Subject: NRC List of AREVA Fukushima 3/19/14 Public Meeting Outcomes
Sent Date: 4/11/2014 5:36:55 PM
Received Date: 4/11/2014 5:37:00 PM
From: Eudy, Michael

NRC list of AREVA Fukushima 3/19/14 Public Meeting Outcomes

U.S. EPR – Fukushima Path to Closure

U.S. EPR Design Certification

Figure 9.4.7-2—Containment Building Low Flow and Full Flow Purge Exhaust Subsystem

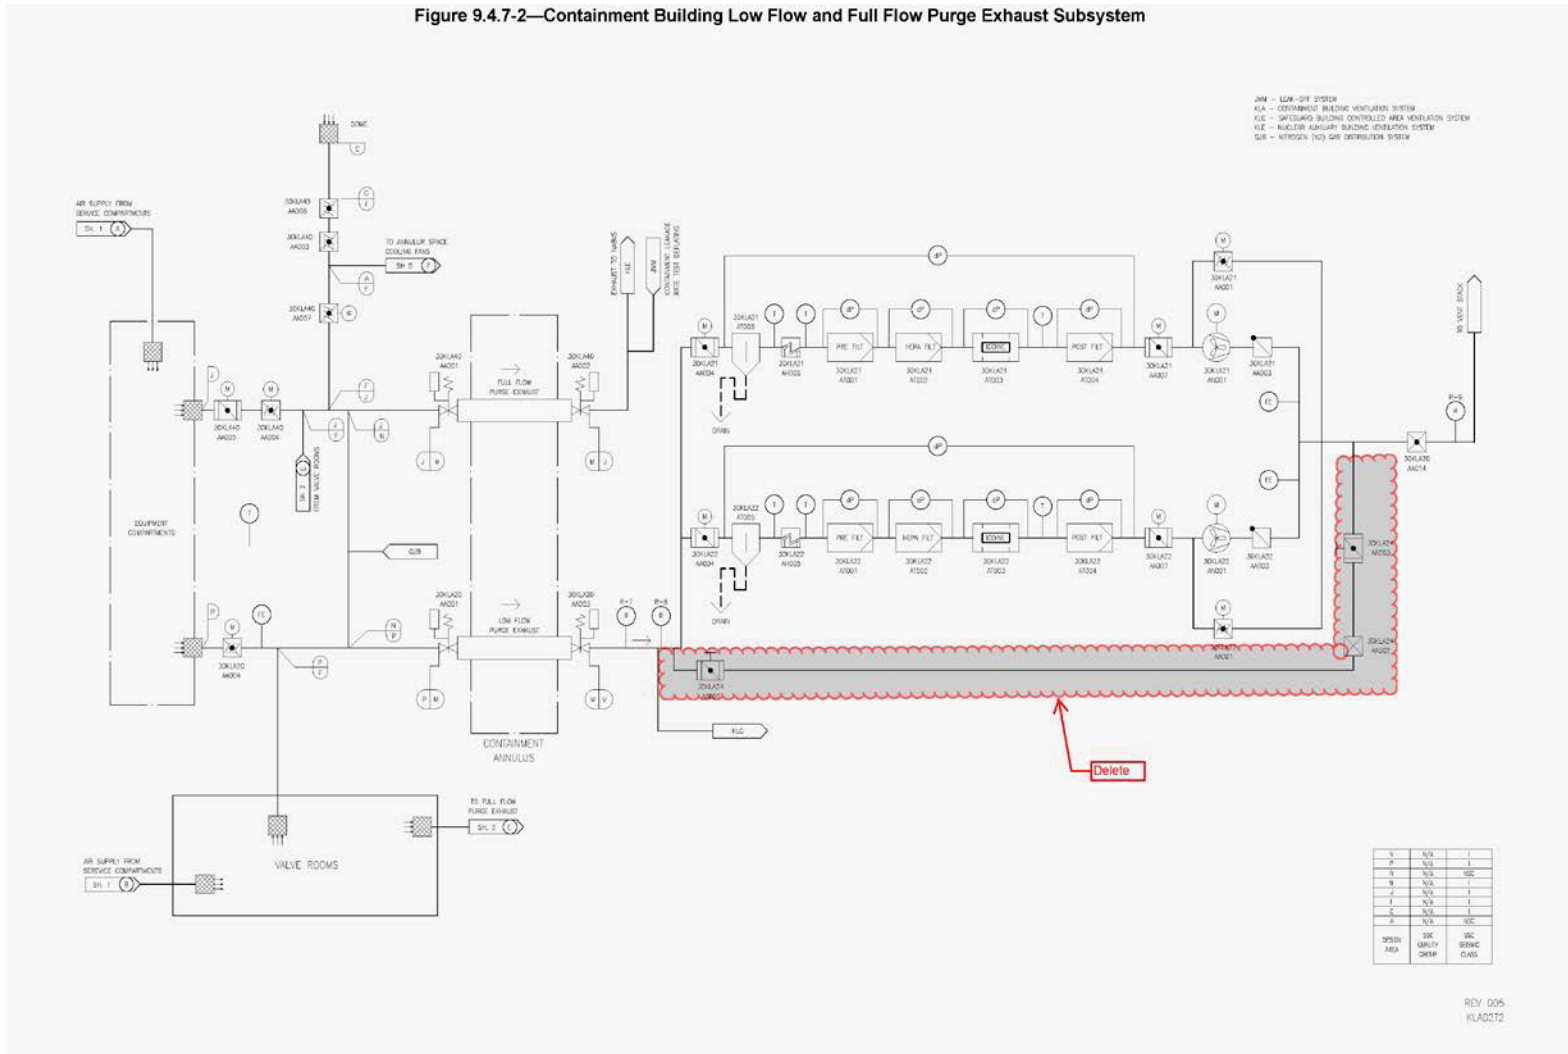
Remove Containment Venting via Low Flow Purge

Change: Remove Seismic Category I bypass ducting and associated isolation dampers from low flow purge system.

Rationale: Resolve NRC questions on viability of containment venting strategy (RAI 598)

Design condition of check valve on discharge of PCIP

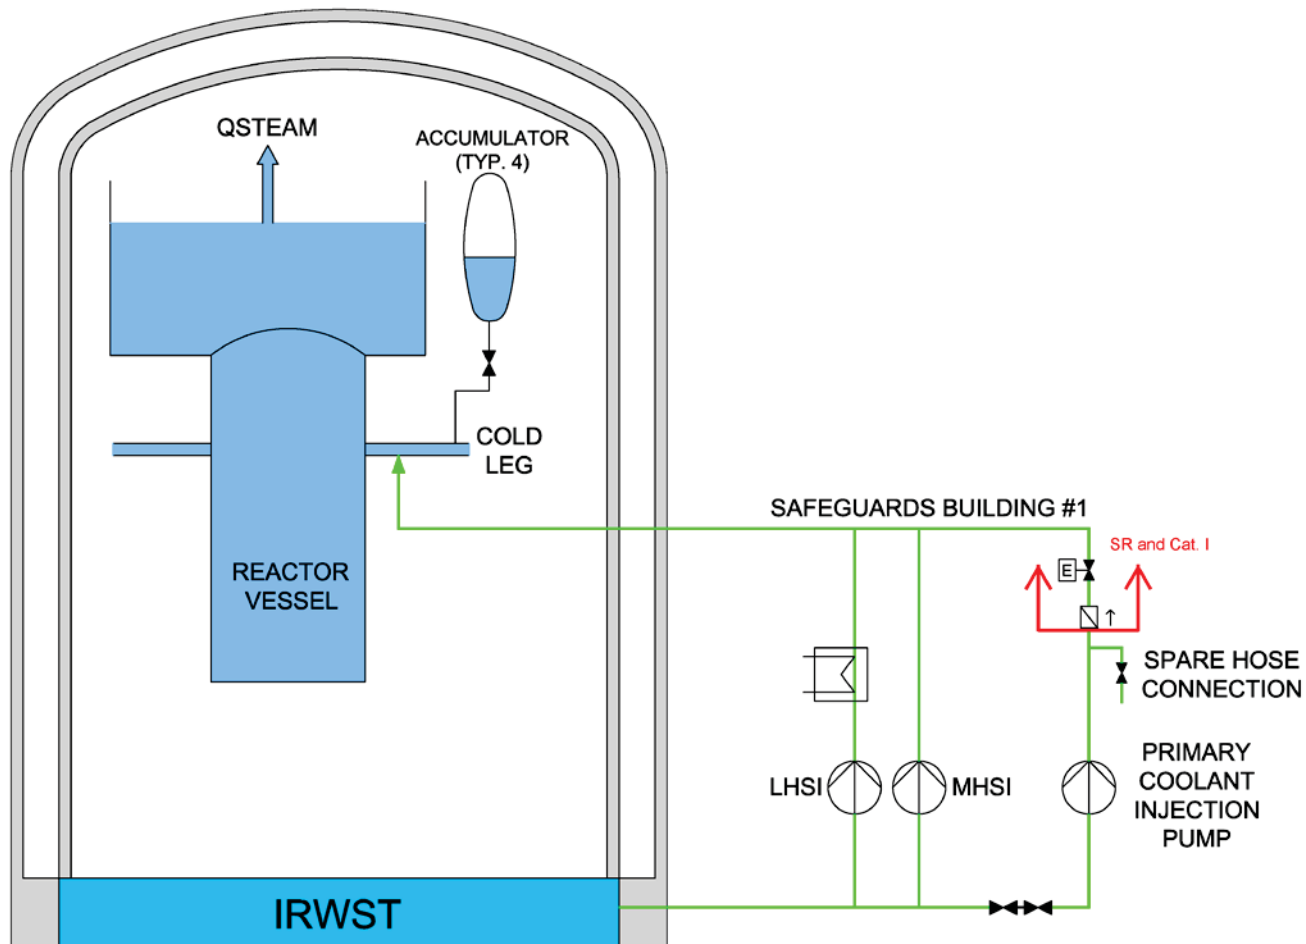
Revise design conditions of check valve on discharge of PCIP

Change: Improve single failure protection at discharge of Primary Coolant Injection Pump (PCIP):

- ▶ Move the safety-related, Category I design boundary condition to include check valve 30JND11AA011.
- ▶ Require that 4" motor operated throttling valve (30JND11AA012) be closed and depowered in Modes 1-4

Rationale: Resolve Condition Report CR 2013-8207 and RAI 626 to improve single failure protection
